Downtown Knoxville Design Overlay District Certificate of Appropriateness

Fee Amount: 50.⁰⁰ Review Date: 12/20/2017 File Number: 12-E-17-DT

Project: Clinch River Brewing

Re: Proposed Changes to Certificate of Appropriateness 3-A-17-DT & 9-B-16-DT

SHEET NO.
a1.0

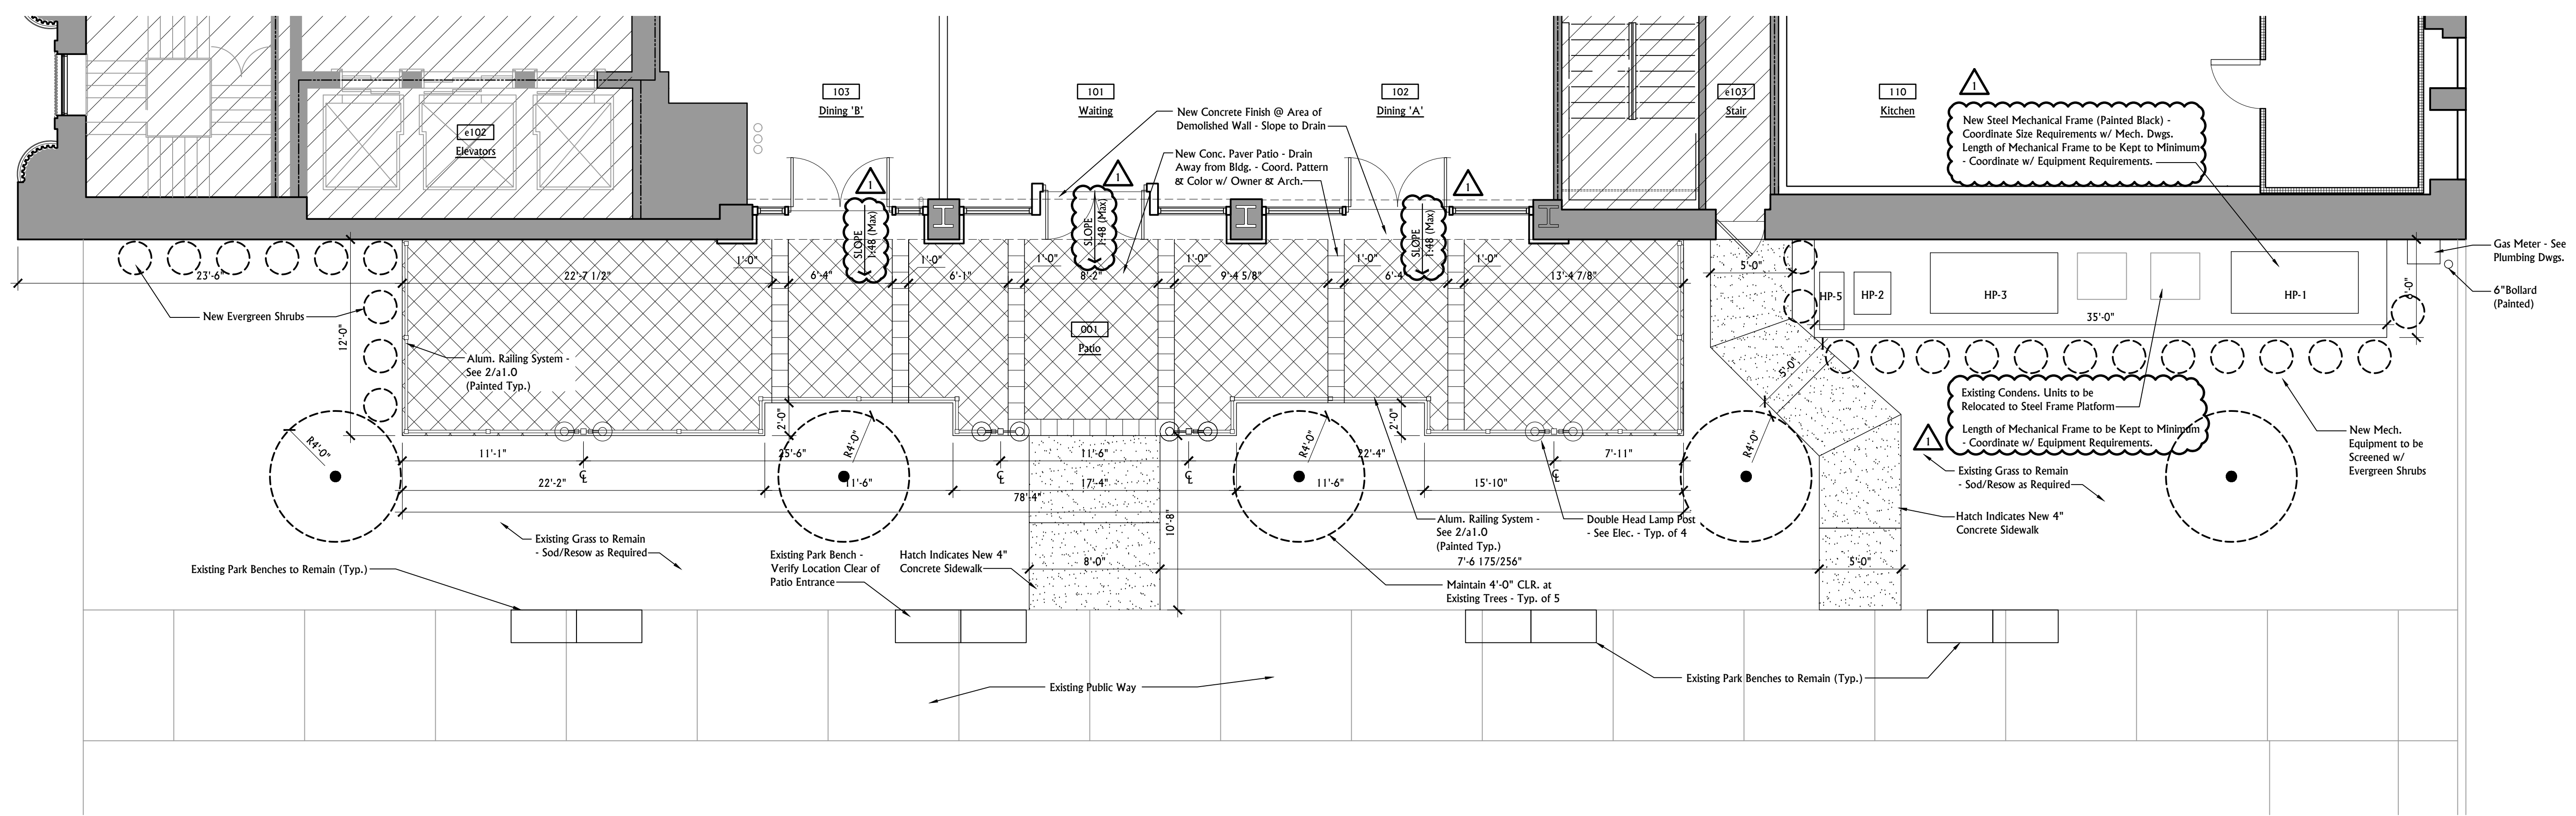
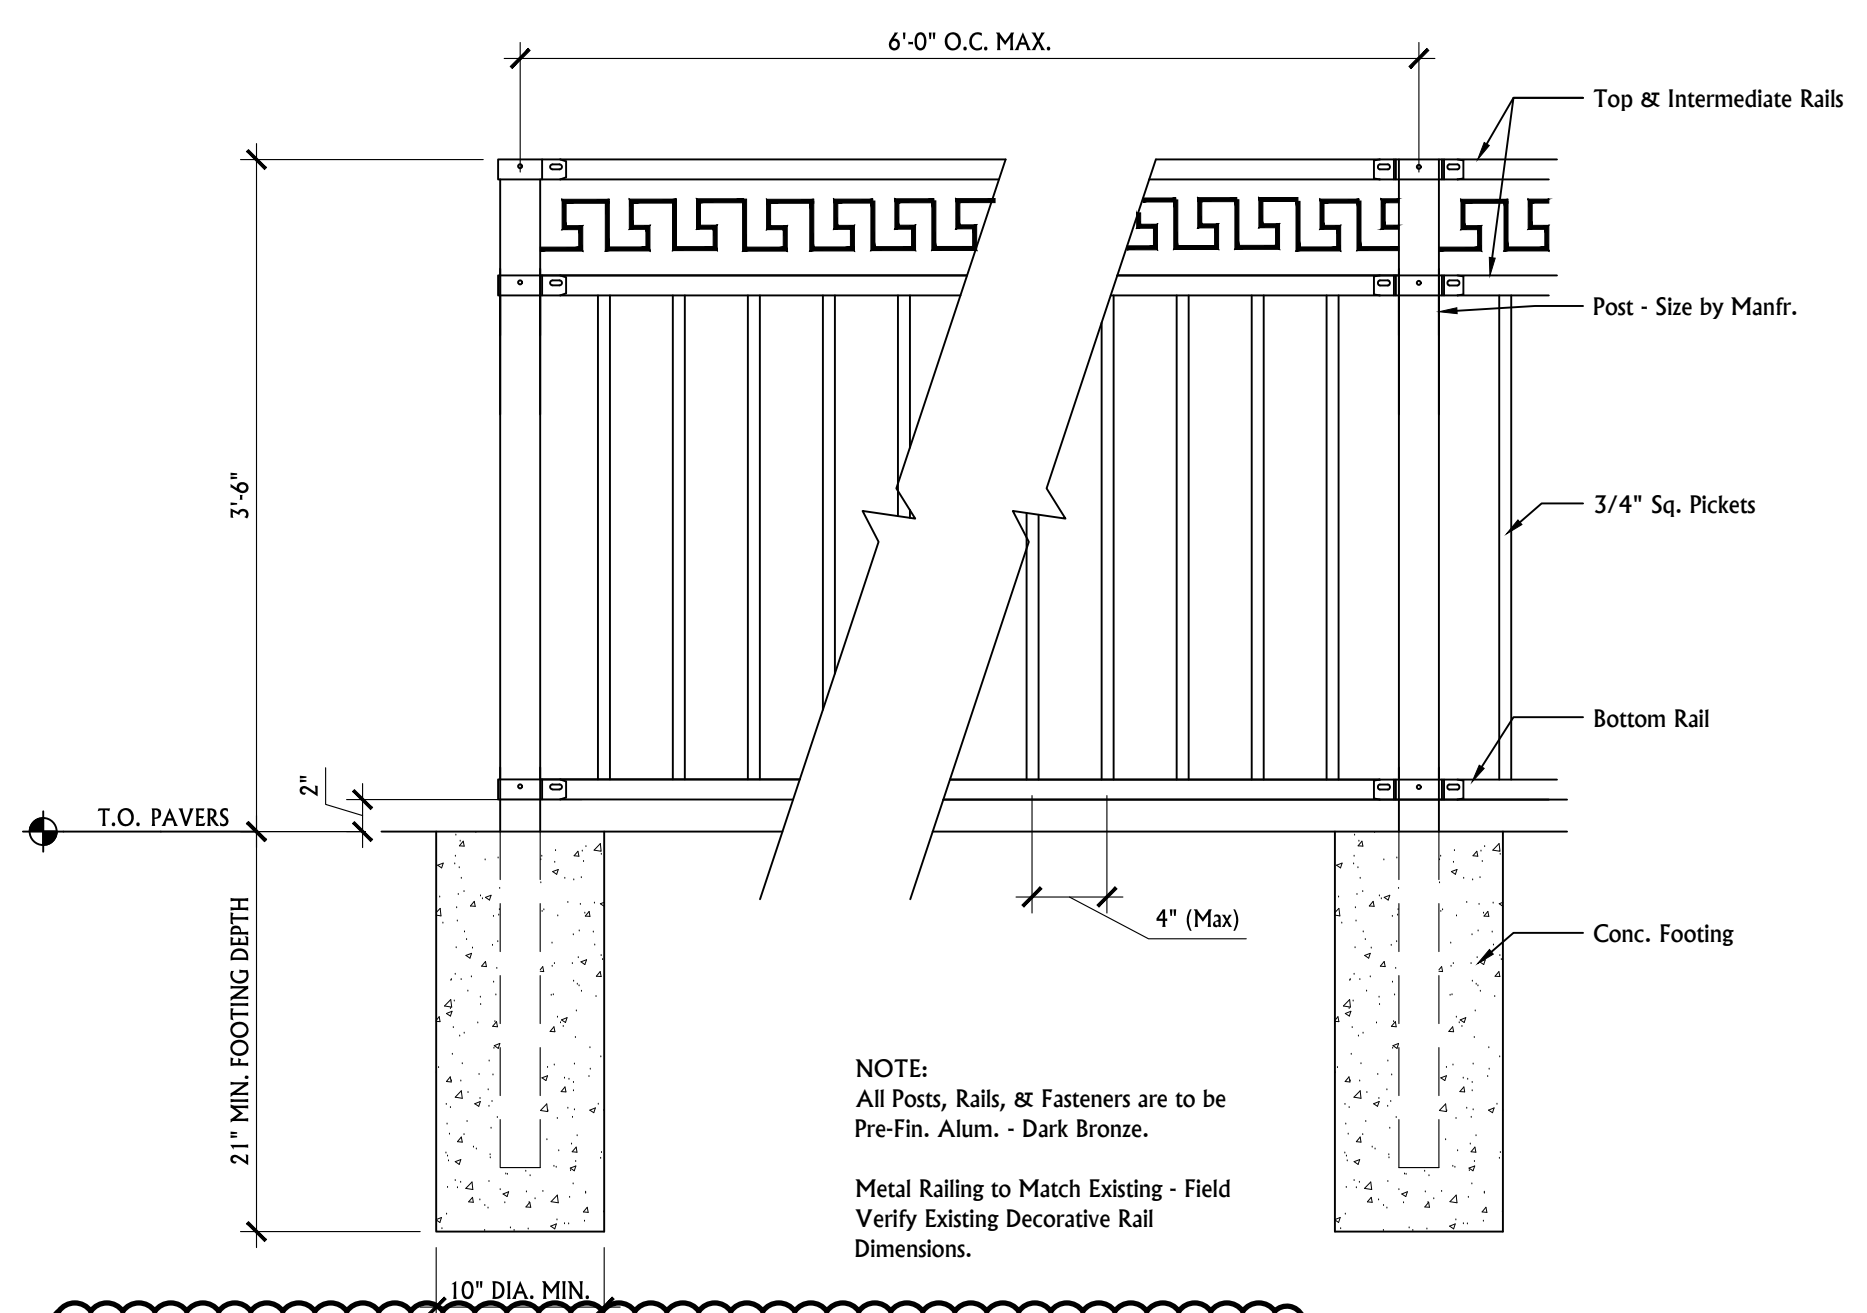
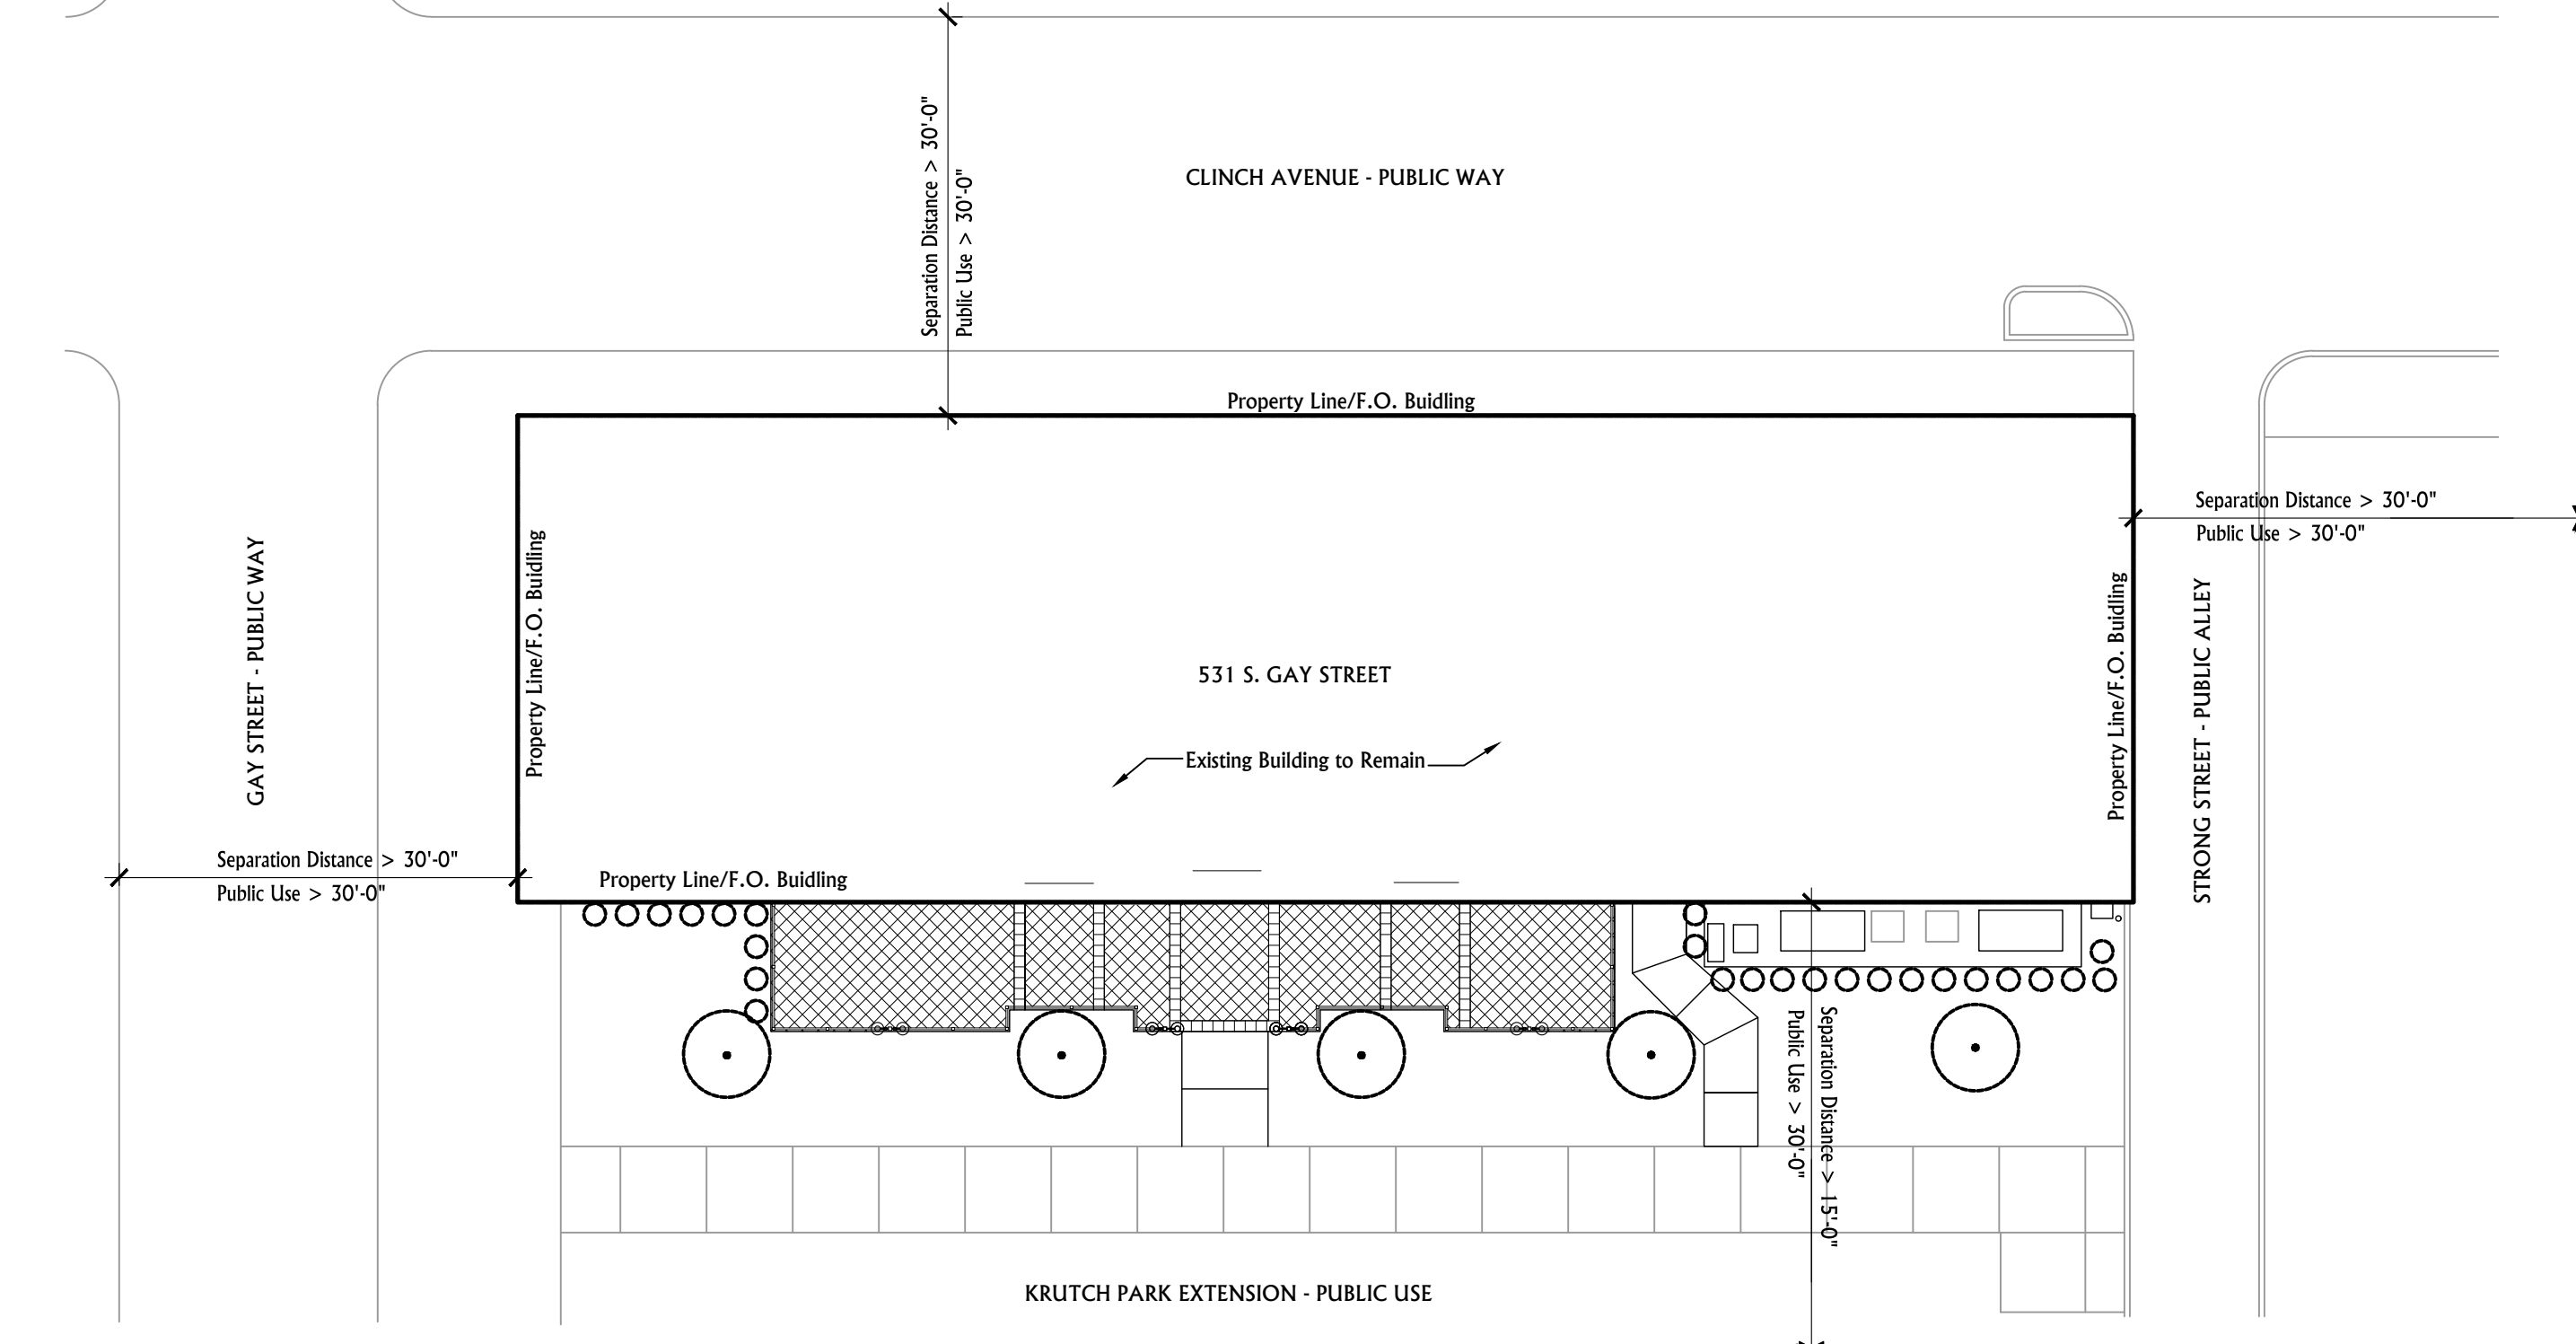
From the previous submission for 9-B-16-DT, we have attempted to maintain the design and patio layout from the original submission. The locations of existing trees and clearance required by the License Agreement with the City dictated the need for recesses in the patio shown on sheet a1.0. Paint colors for the storefront and brick veneer shall be as shown on

SHEET NO.
a3.1

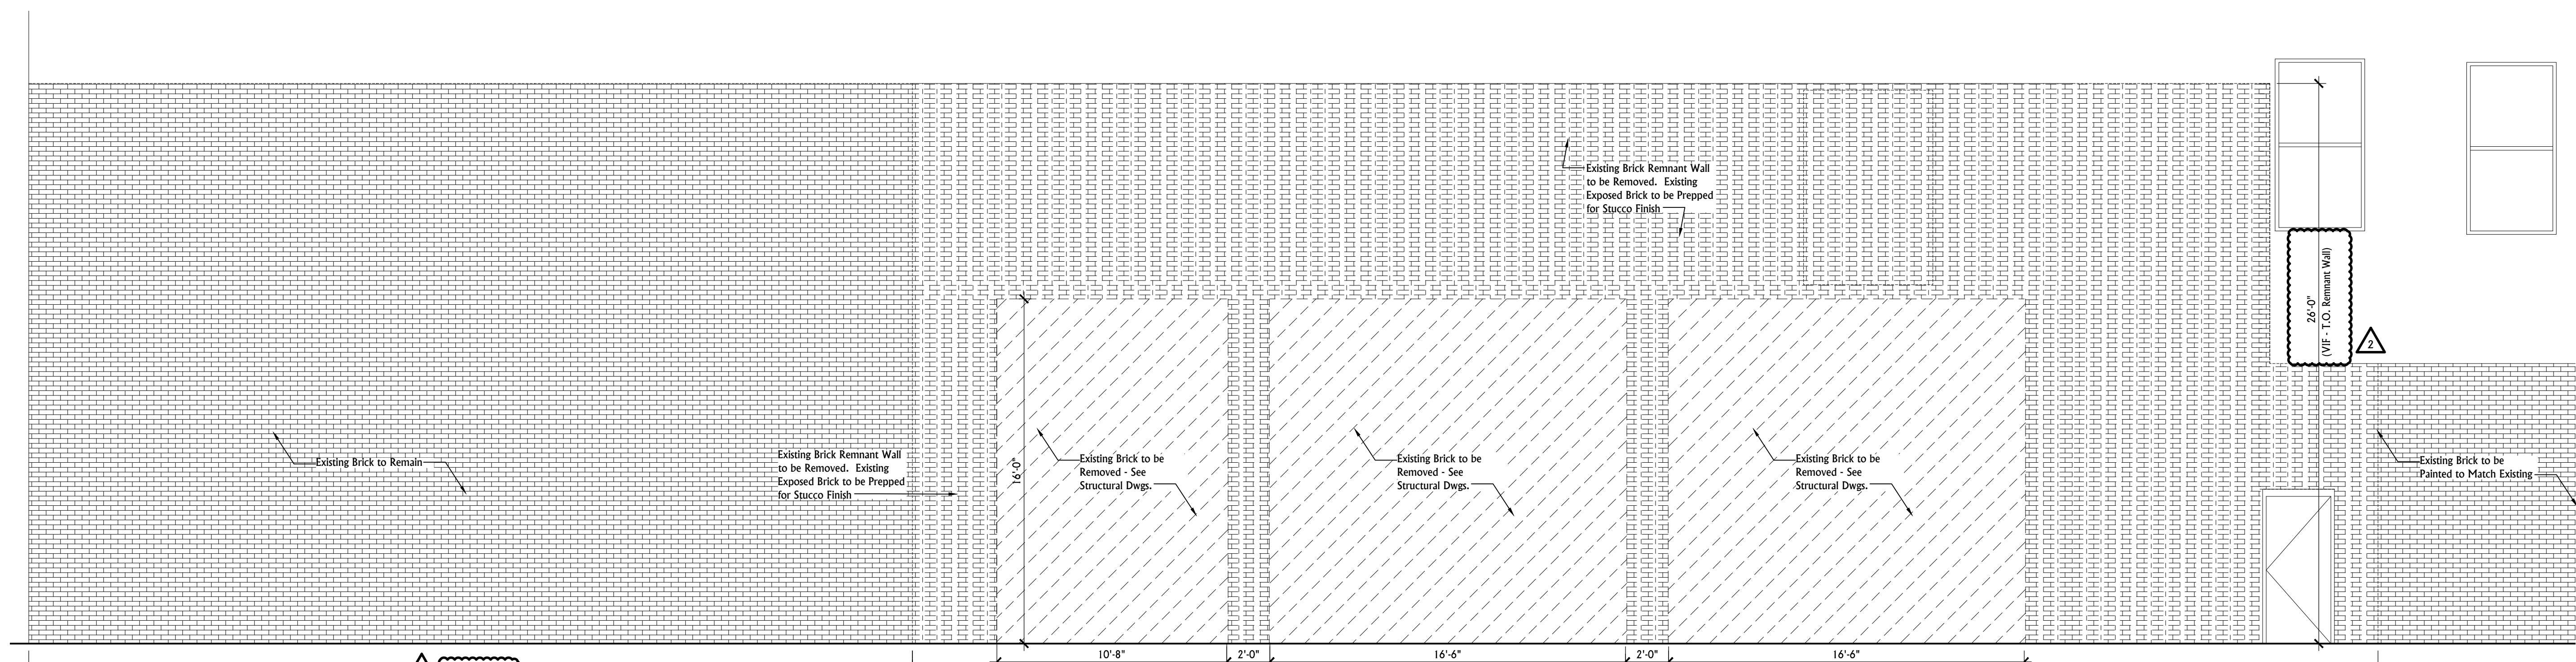
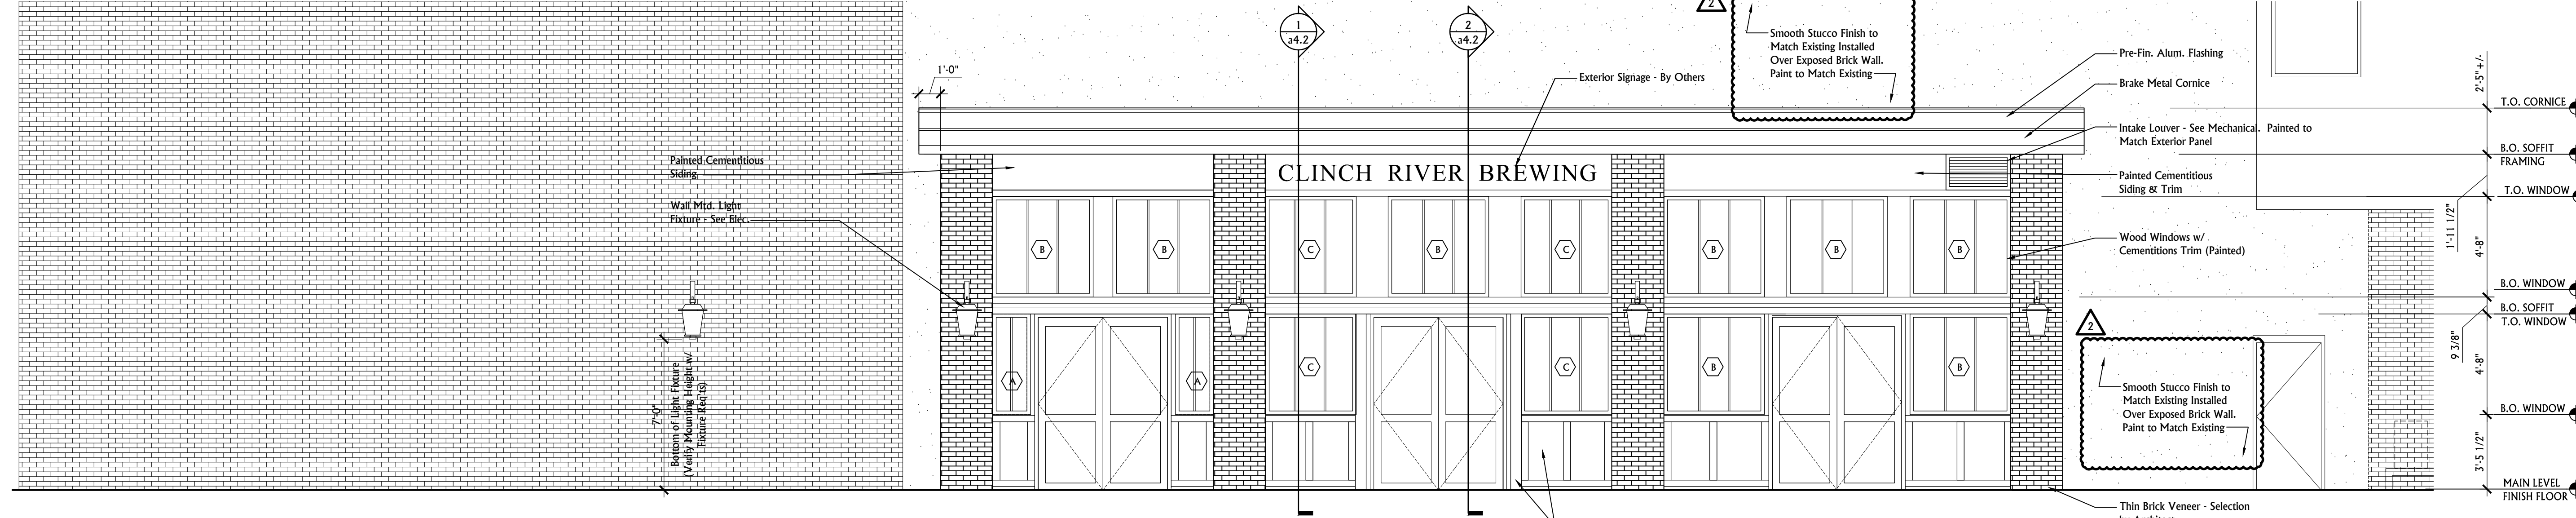
From the previous submission for 3-A-17-DT, we have updated the elevation facing Strong Street to reflect accurate locations for mechanical louvers. We have also eliminated the opening for the roll up door and gate per the owner's direction with changes to the project layout. All new louvers and stucco shall be painted to match the existing building. The metal stand for the HVAC equipment has been enlarged based on requirements for equipment. Please see revised a1.0 indicating the proposed mechanical platform size. This platform will be painted black and will still be concealed with evergreen shrubs.

- 1.) A License Agreement has been obtained from City of Knoxville and approved by City Council.
- 2.) Proposed sills have been removed from the project.
- 3.) Brick infill will replace the existing sills where new doors will be cut in. Please also note that the proposed doors on the rear elevation will swing into the building and not into the alley.
